# Joint Regional Planning Panel

Meeting Date: 7 October 2014

<b>JRPP Number:</b>	2014 SYE050
<b>DA Number:</b>	DA-2014/319
<b>Local Government Area:</b>	ROCKDALE
<b>Proposed Development:</b>	<p>Demolition of existing structures and construction of a mixed use development including 31 commercial suites, 338 residential units, youth centre and associated ball courts, basement parking and torrens title subdivision creating 3 lots. The proposal includes a park with an area of 948 sqm</p> <p>A planning proposal (subject of a separate Council assessment) has also been lodged affecting the subject site seeking an increase in height on the corner of the site with Princes Highway to 41m (from 31m) and increasing the FSR across the site to 2.92:1 (from 2.5:1).</p>
<b>Street Address:</b>	213 Princes Highway & 4 Wardell Street, ARNCLIFFE NSW 2205
<b>Applicant/Owner:</b>	Stephen Bowers Architects
<b>Number of Submissions:</b>	<p>First Exhibition: 11 individual submissions and 202 pro forma letters</p> <p>Second Exhibition (amended plans): 8 individual submissions and 18 pro forma letters</p>

<b>Recommendation:</b>	Refusal
<b>Report by:</b>	External Consultant - GMU

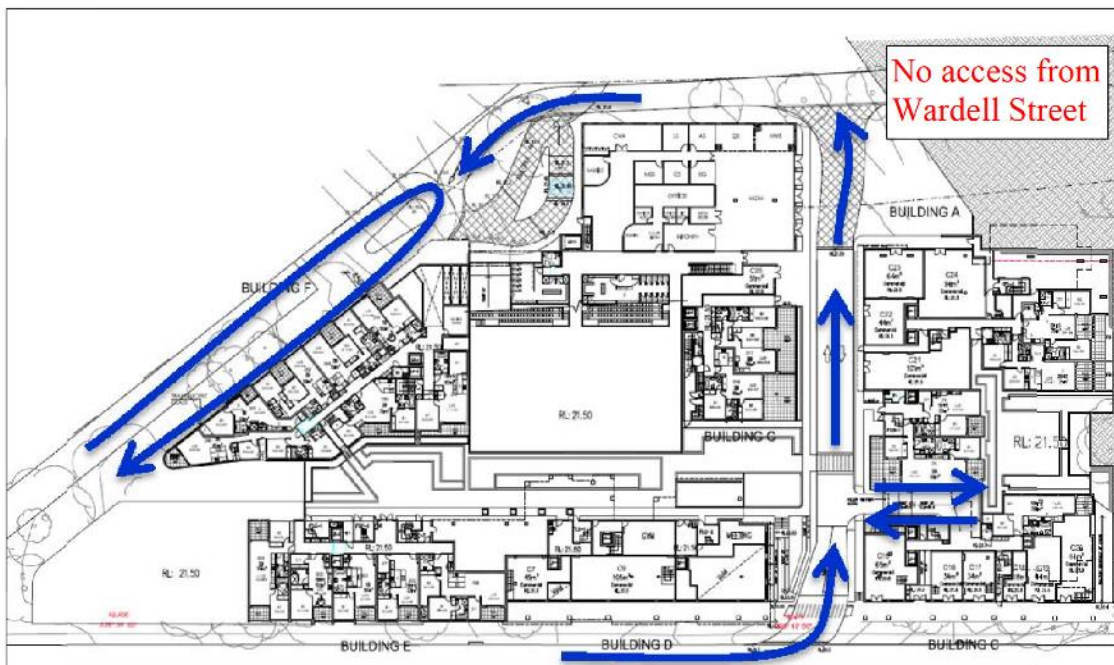
The proposed development will create up to 60 vehicles in PM peak hour. The removal of the Wardell Street connection will require traffic to access the site only from Townsend Place or Princes Highway. For south bound vehicles, they will require a detour via West Botany Road and Terry or Bestic Street to turn right into Princes Highway then into the development site.

As some of the current intersections turning right into Princes Highway are unsignalised, these vehicles may require a complex detour of nearly 2km or crossing three lanes of traffic along Princes Highway. This is not a desirable outcome. The applicant has failed to assess how traffic arriving from the north and east will access the site and propose solutions to address potential traffic issues.
